## English Channel Airspace Requirements – (ACP 2021 088)

Stage 2A: Options Development – Airspace Design Options  
24 February 2023.

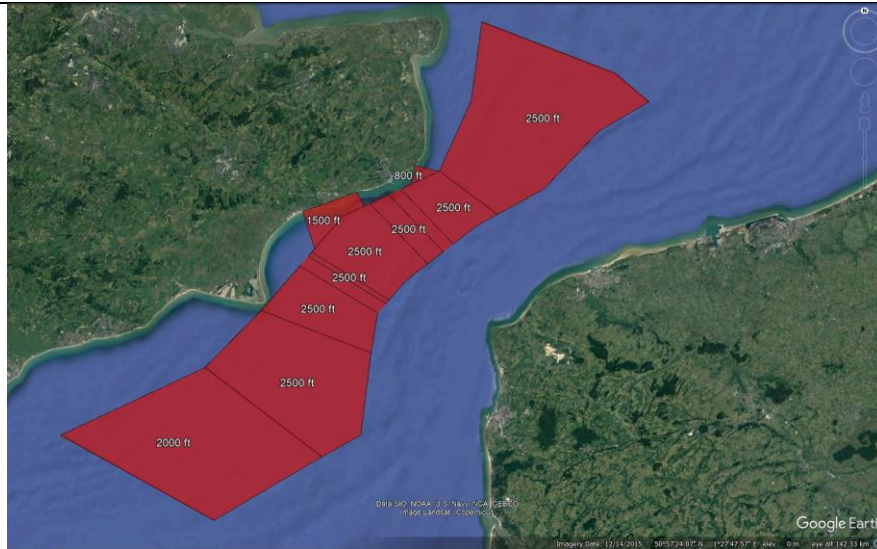
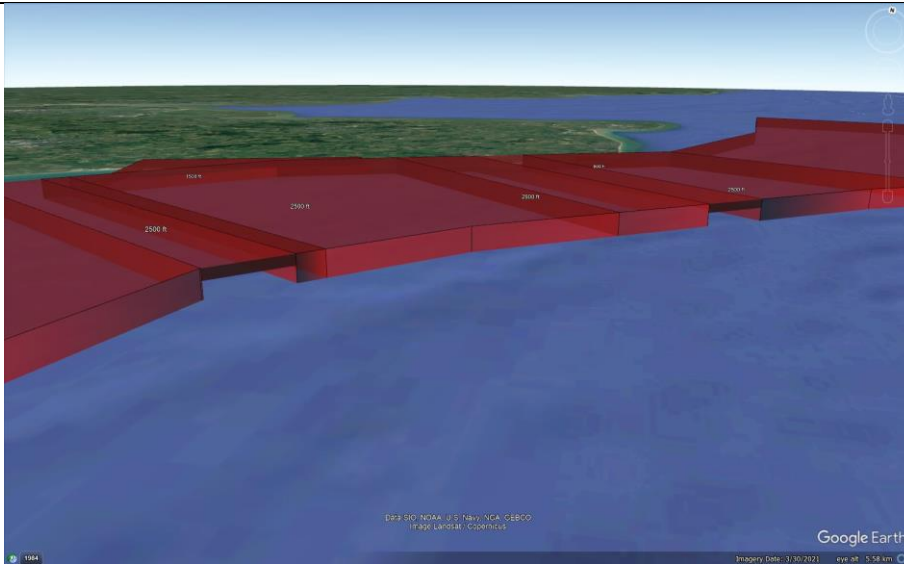
- We suggest that areas E, D, B, and G be further subdivided into smaller operational areas. These areas would only be active when the UAS is flying, and a designated airspace controller would manage the activation and deactivation of the airspace. This would allow access to the areas of the DA that were not active to manned fixed-wing SAR operations and potentially other airspace users. All operators would need to be diligent in using the airspace activating/deactivating as required by the operational need. The DACS provider would be aware of which areas are active and be able to provide this as a service to other users, thereby segregating the UAS operations from manned aircraft operations.

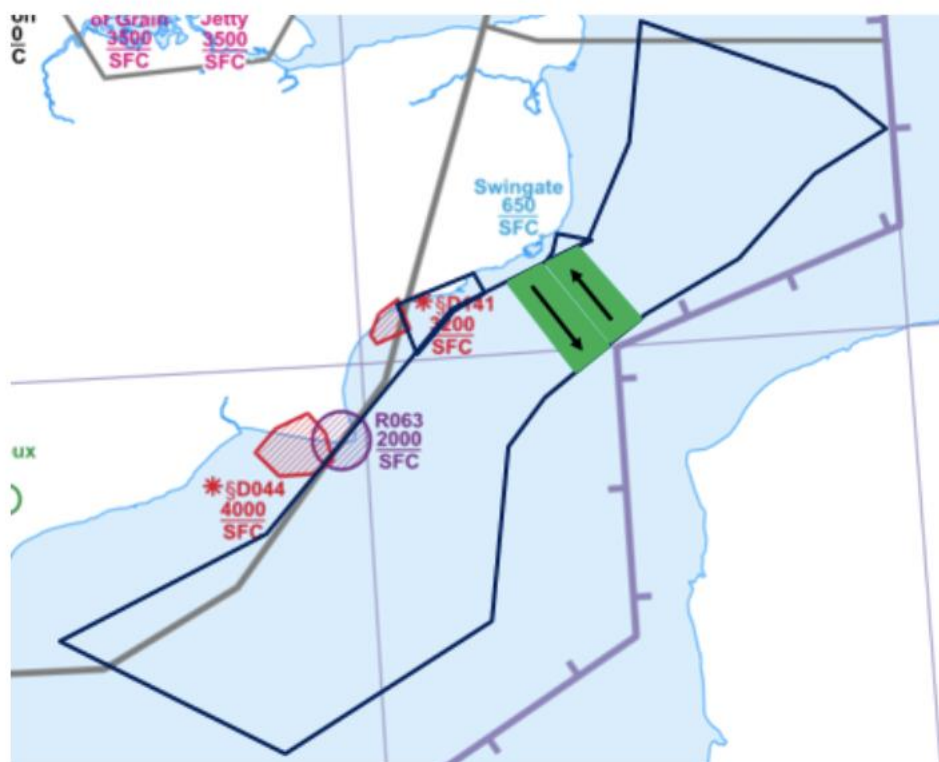
Thank you for the feedback of particular interest was the concerns regarding option 2.

A number of stakeholders have requested variations to Option 2, where by the transit corridors are over the shortest route between the UK and France. I have attached an initial sketch on what this might look like, but following your concerns regarding option, do these remain if the transit corridors are across the shortest route across the channel?
